**E7401A-06**

# S E R V I C E N O T E

## E7401A 1.5 GHz EMC Analyzer

**Firmware Update to Fix High Noise Floor on the Analyzer Screen.**

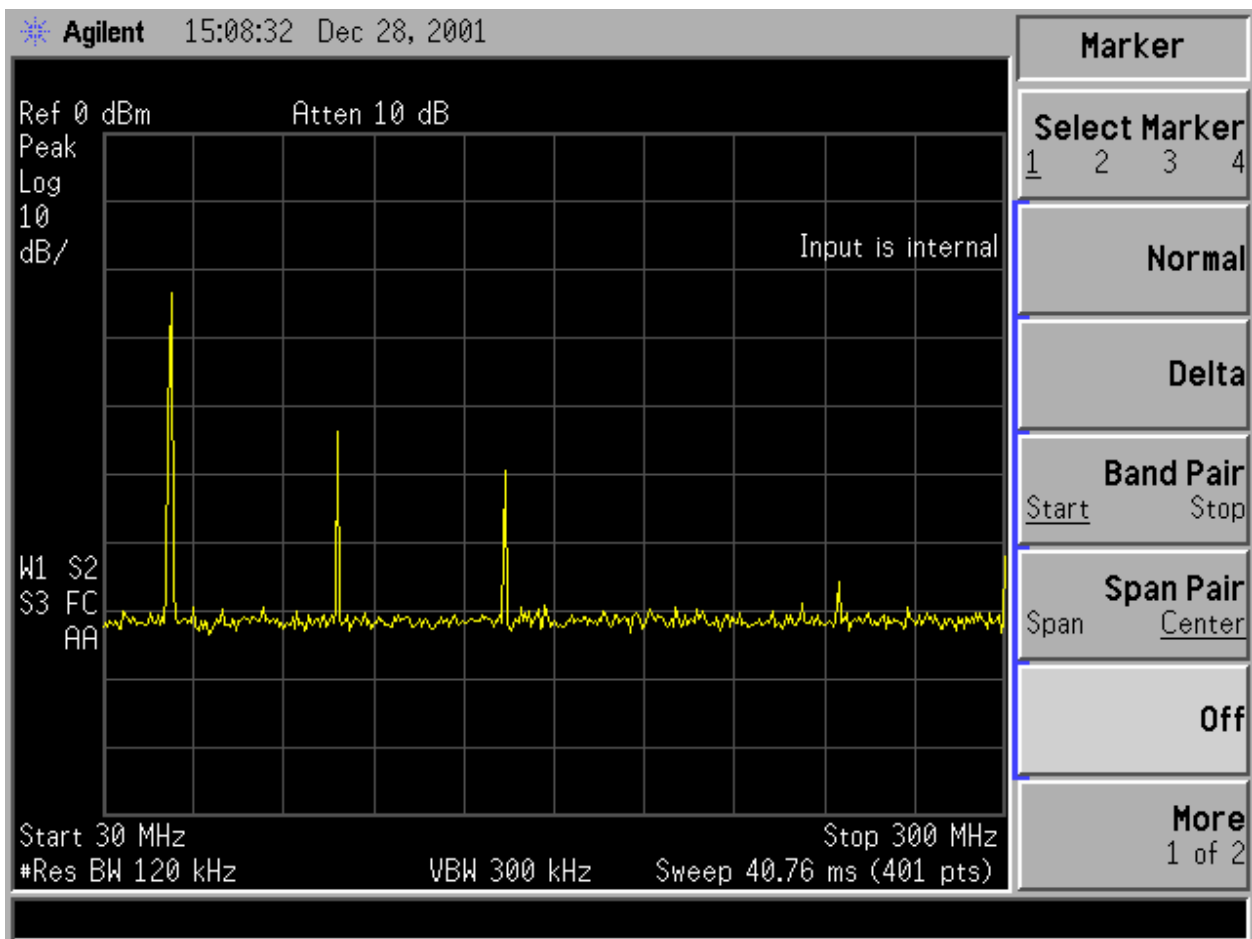
Press Preset, Frequency ->Start Freq 30 MHz, Stop Freq 300 MHz, BW/Avg. ->Resolution BW 120 kHz, Input ->Amptd. Ref ON.

You should see the Alignment signal (50 MHz) and harmonics on screen as shown below.

Press System, More 1 of 3, More 2 of 3, Service –2010 Enter, Service, Align, LO. If the instrument is affected, then either the Align signal & harmonics will disappear or they will move around quickly and erratically on screen. If this occurs, contact the customer and verify the latest shipping version of ESA firmware can be upgraded in their instrument. If the instrument has option B72, Expanded Memory the instrument can be upgraded to the latest and greatest firmware. Otherwise, A.07.05 is the highest revision allowed. If the customer cannot accept the new firmware, contact Agilent Customer Support At PGU, SA-SUPPORT or call us in the U.S. A. at (707) 577-6801.
